Docket Nos. 50-280  
and 50-281

The Commission has issued the enclosed Amendment Nos. ~~53~~ and ~~52~~ to Facility Operating License Nos. DPR-32 and DPR-37 for the Surry Power Station, Unit Nos. 1 and 2, respectively. This is in response to your application dated August 31, 1978, and supplemental letters dated December 28, 1978, January 19, 1979, and May 4, 1979.

Amendment No. 53  
License No. DPR-32

Amendment No. 52  
License No. DPR-37

Offsite Organization for Facility Management and Technical Support

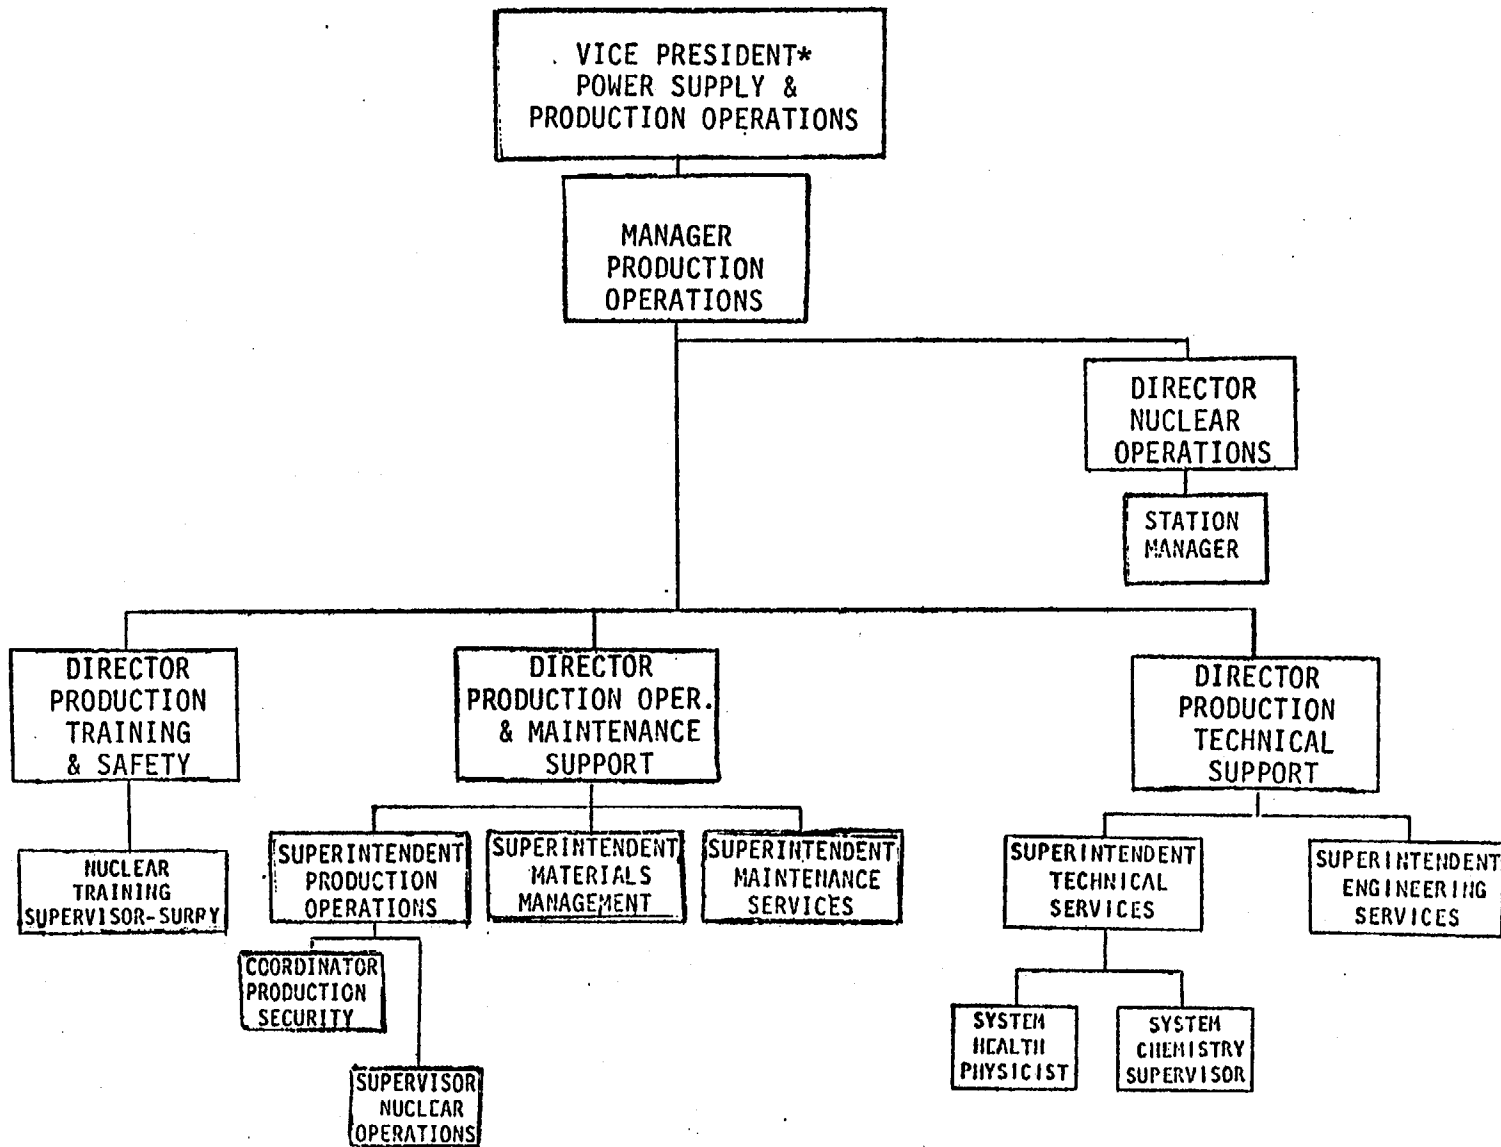
The amendments revise the Technical Specifications to (1) reflect reorganization of the Production Operations Department onsite and offsite, (2) delete reference to the respiratory protection equipment since this item is now covered by 10 CFR 20.103 of the Commission's regulations, (3) increase the fire brigade training and drill interval to 92 days, and (4) incorporate several minor clarifications and typographical corrections.

We have found that the reorganization of the Production Operations Department onsite and offsite is administrative in nature and, as such, does not decrease the overall effectiveness of that department. This change conforms to our current guidance and is acceptable. The minor clarifications and typographical corrections do not change the intent of the Technical Specifications and therefore, are acceptable.
